PLAN AND PROFILE OF PROPOSED STATE HIGHWAY

PRINCE WILLIAM PARKWAY INTERCHANGE AT REALIGNED BALLS FORD ROAD

VDOT Proj.No.6234-076-266

Notice of Design Change (NDC) #02
JUNE 2021

Curb Return Profiles

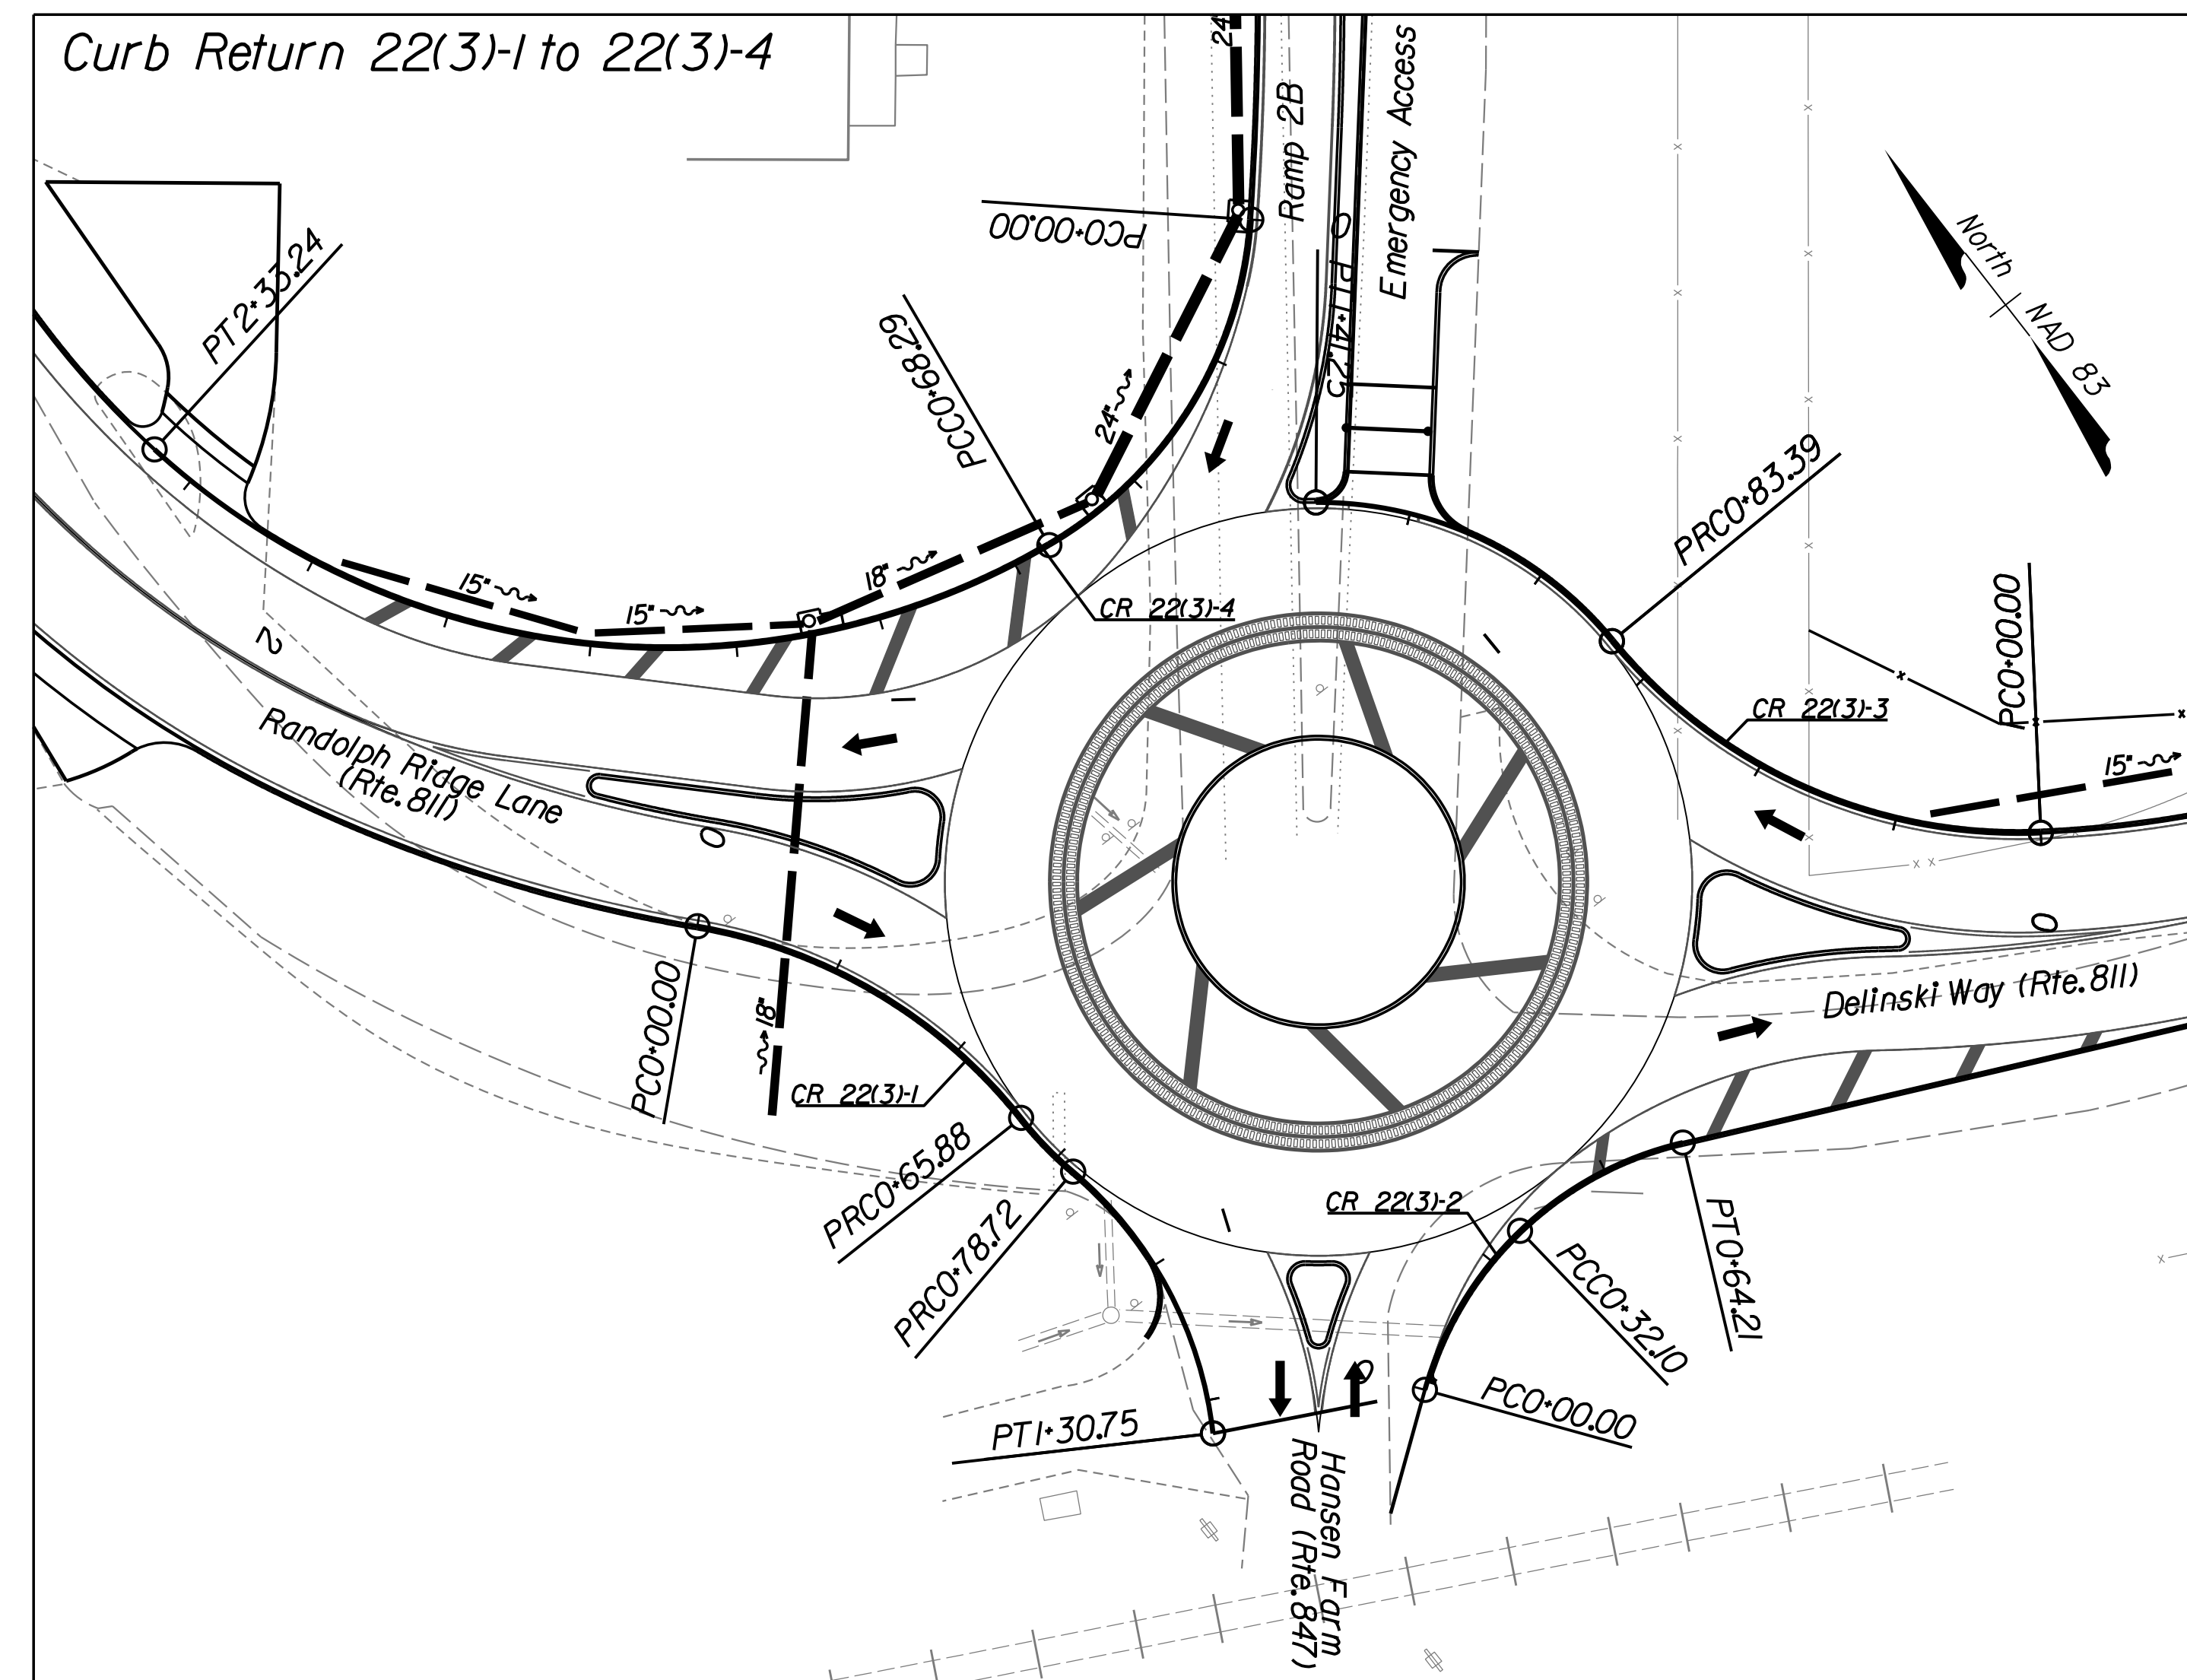
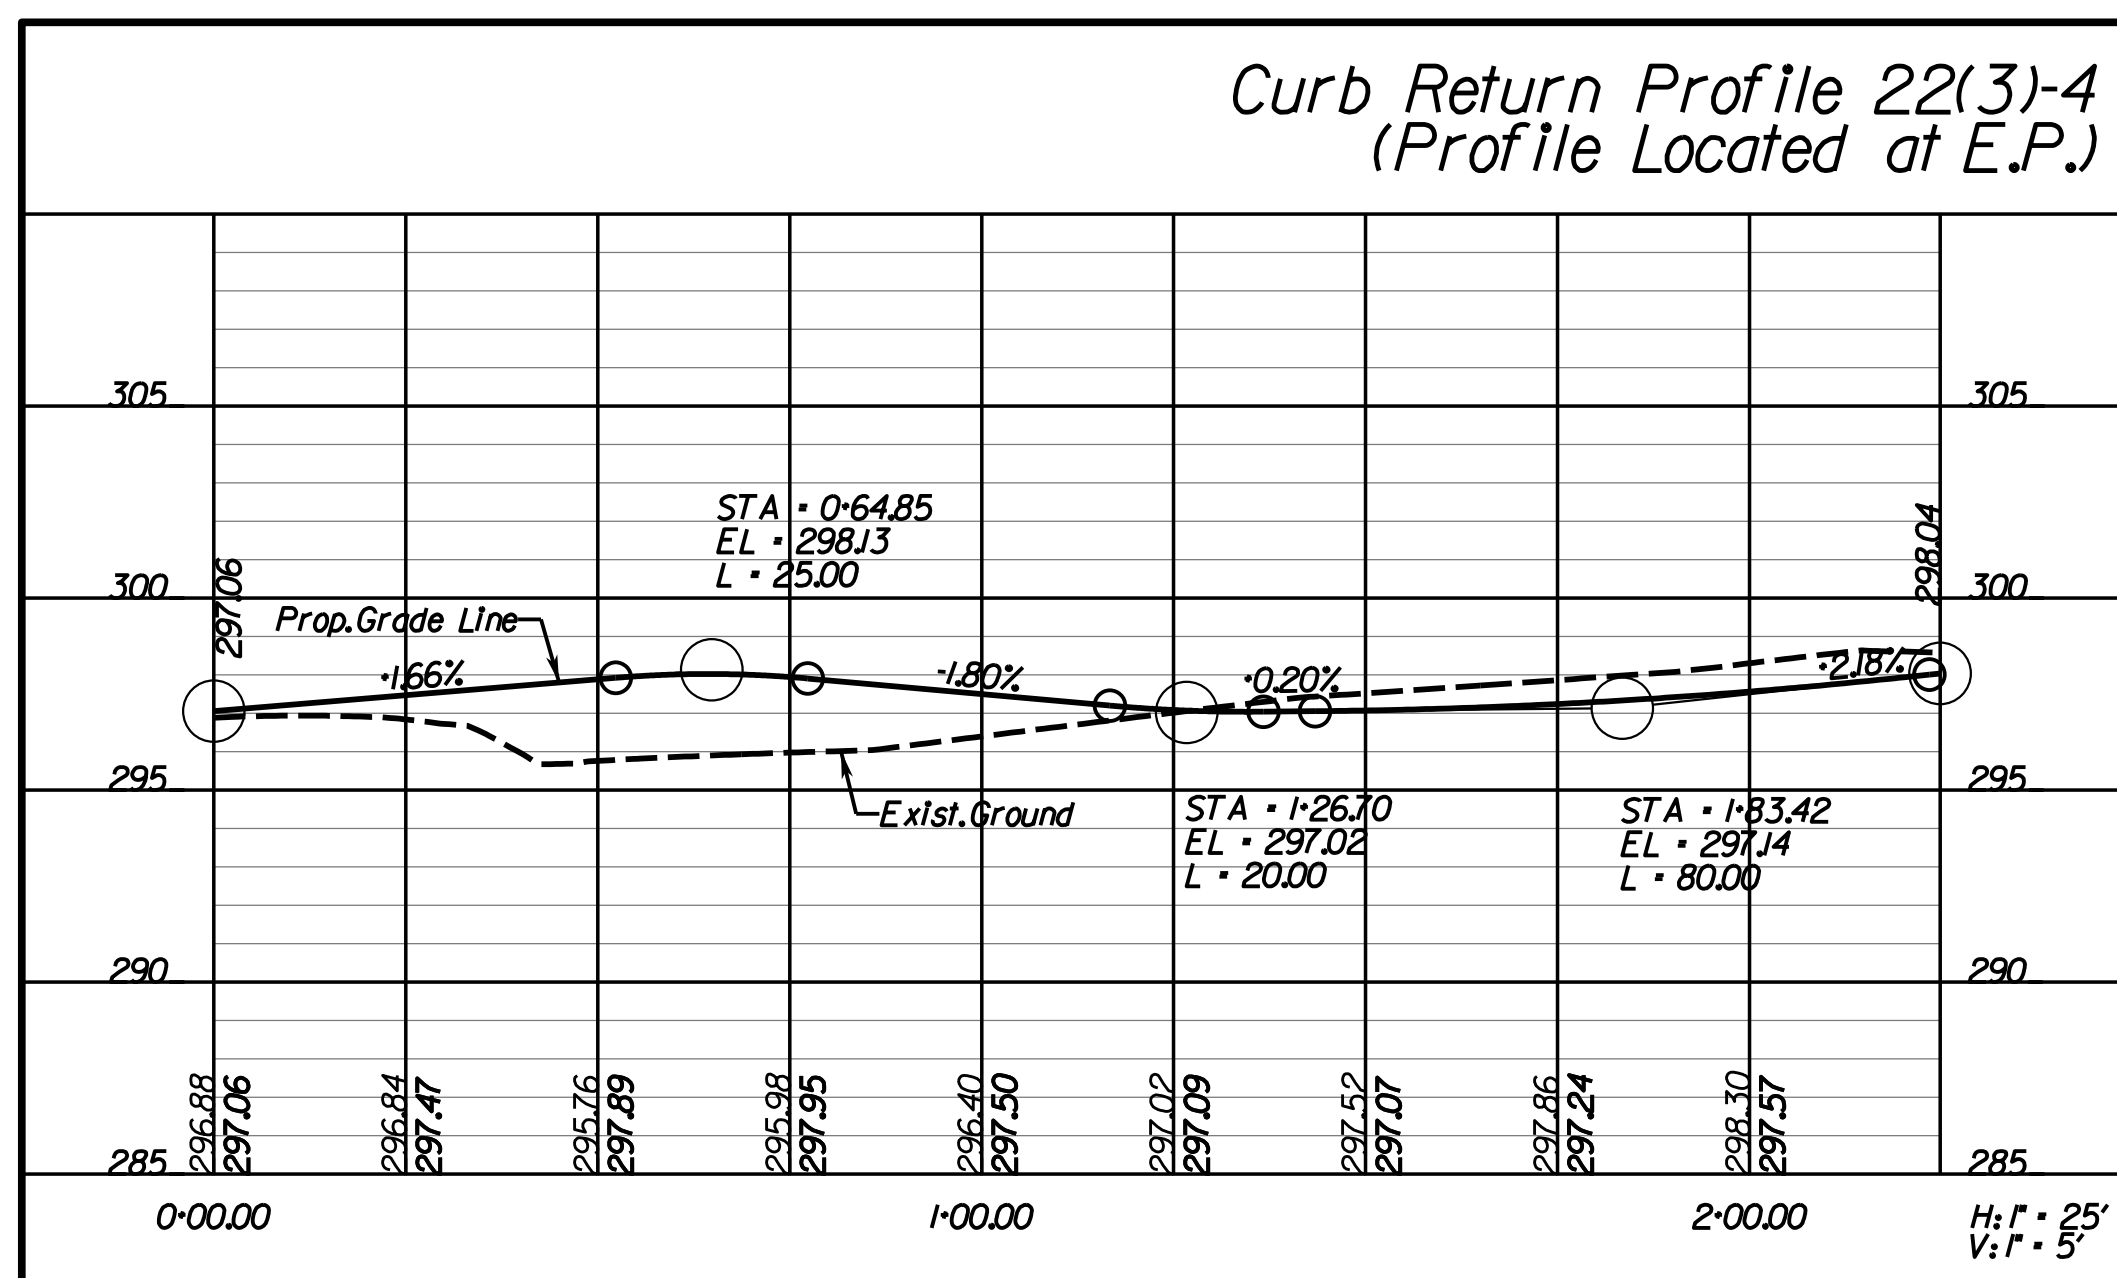
02 Added sheet for roundabout curb returns.

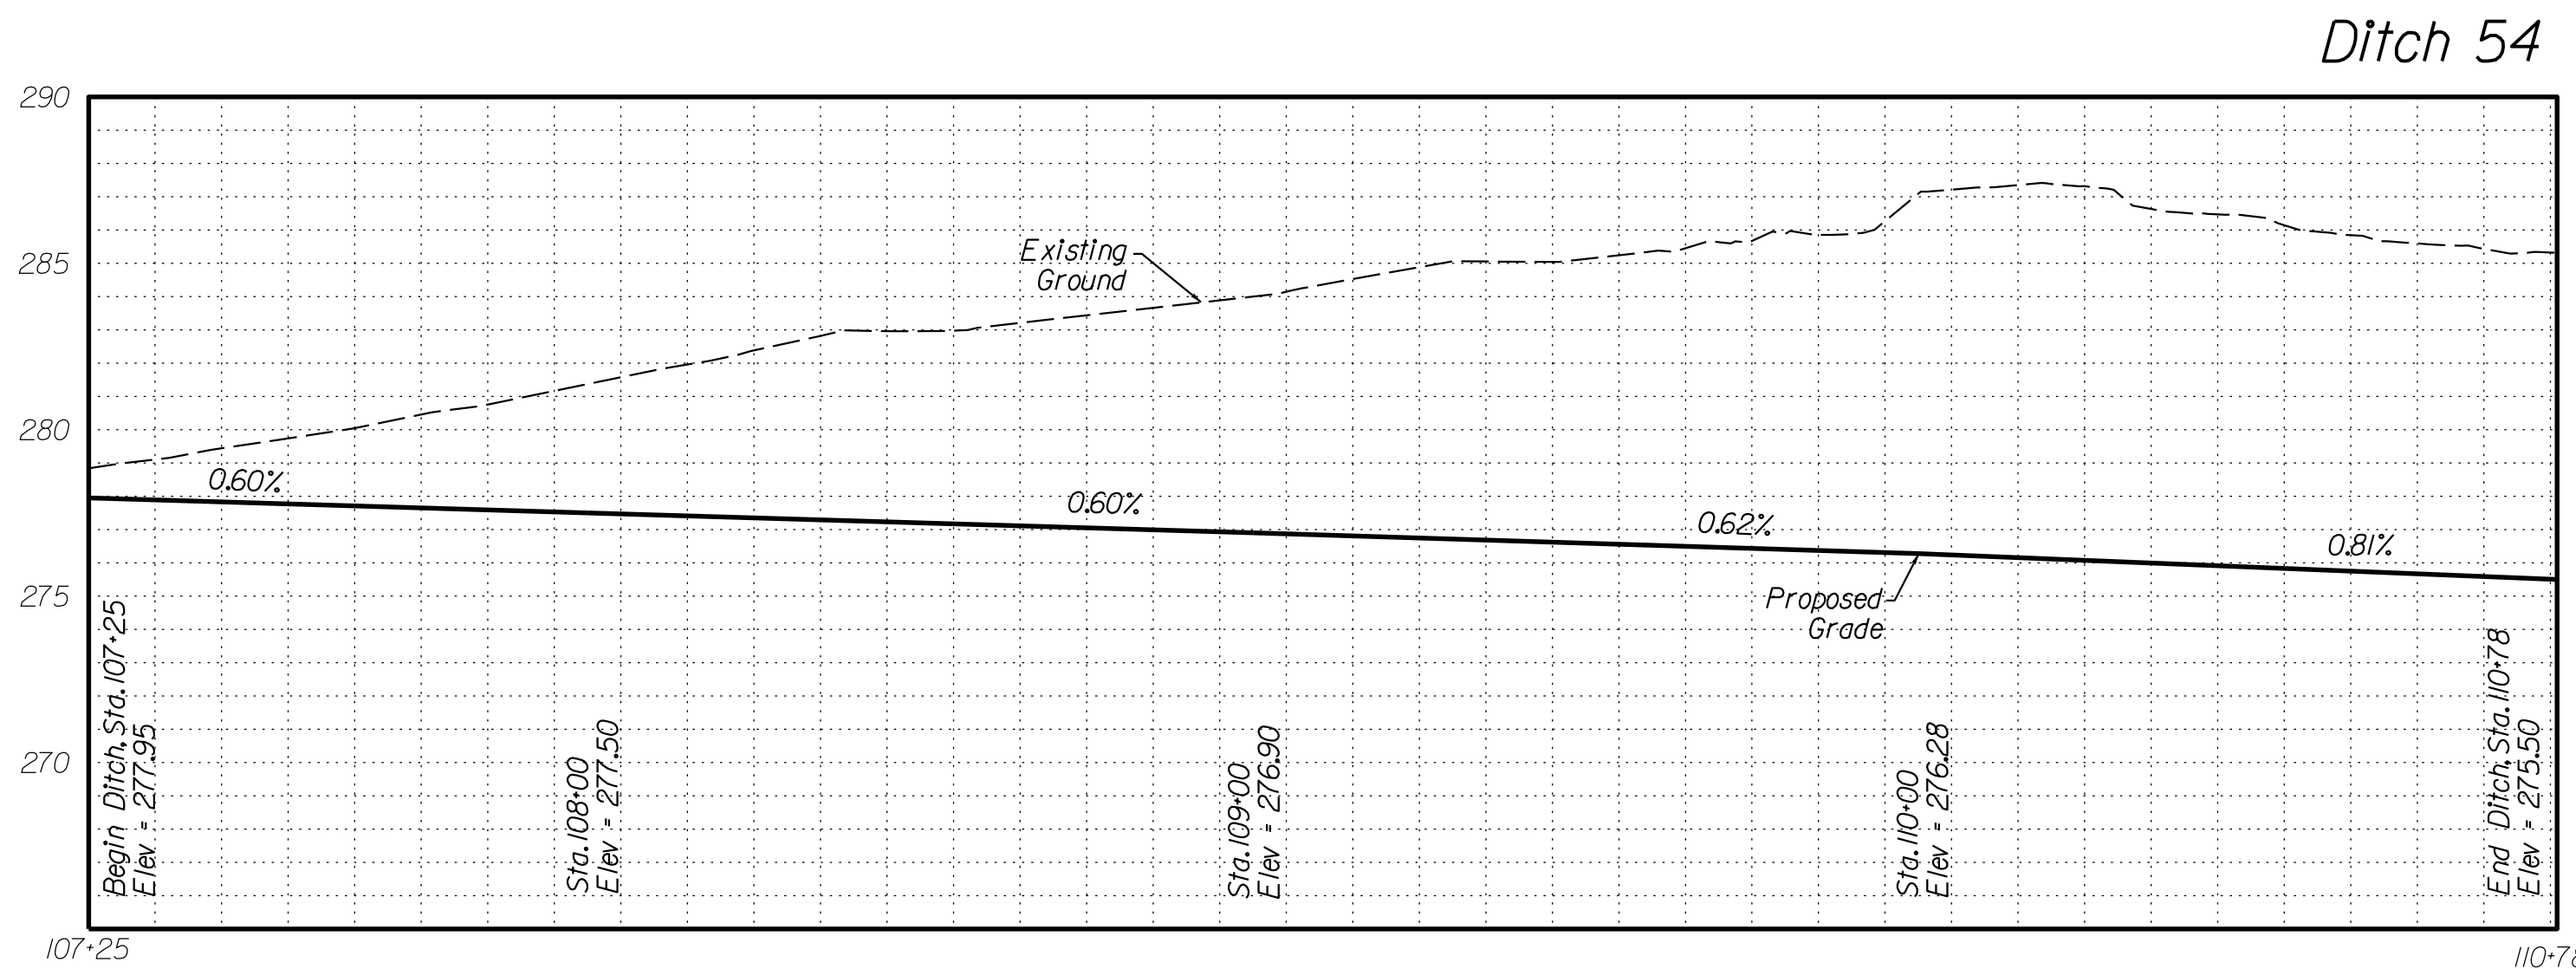
02 Added sheet to include roundabout ditch profiles.

22(1)-1 to 22-3

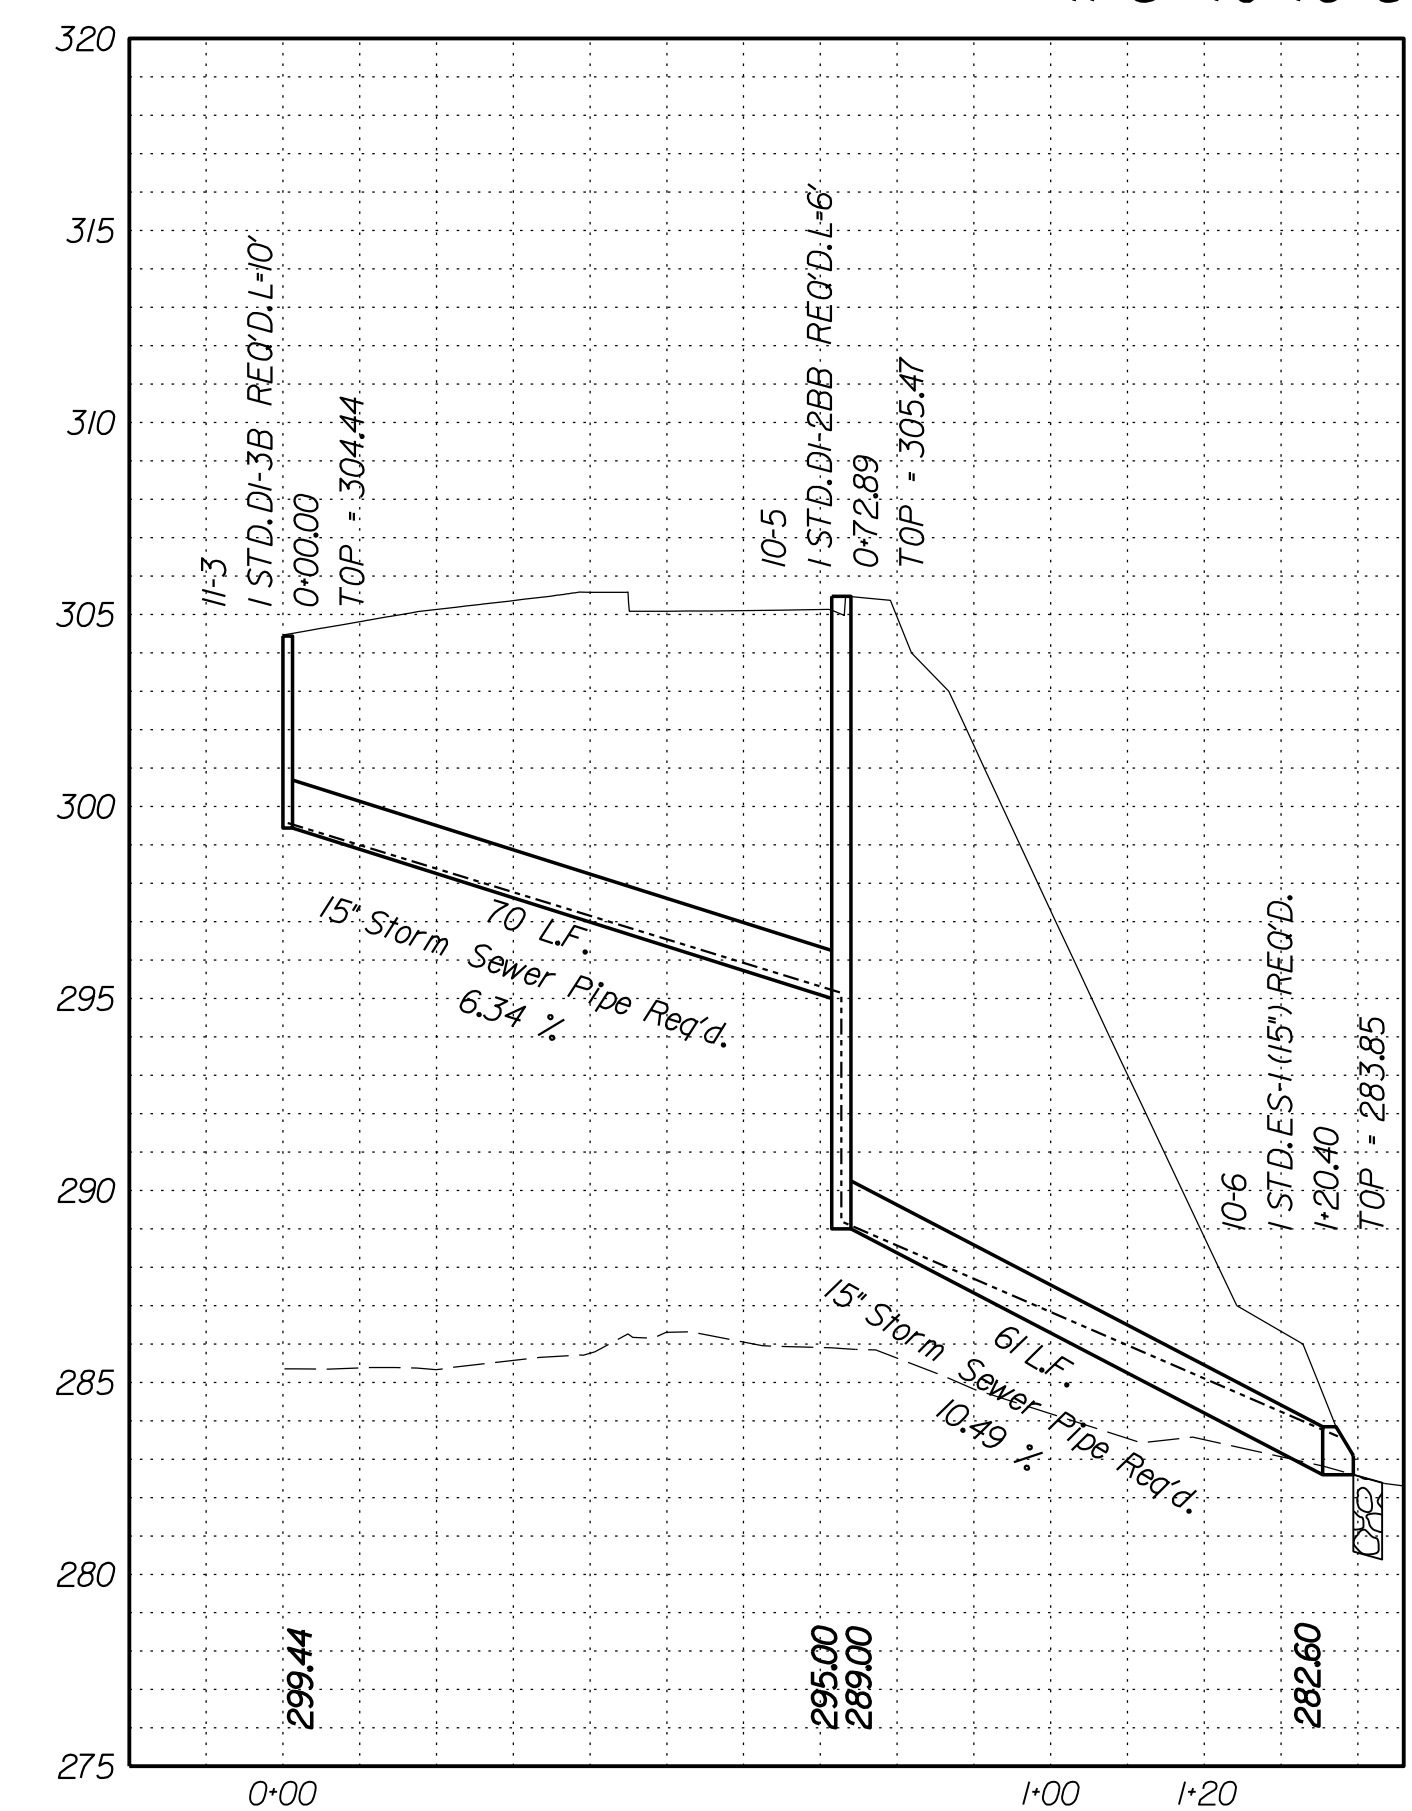
02 Revised 22(1)-1 to 22-3.
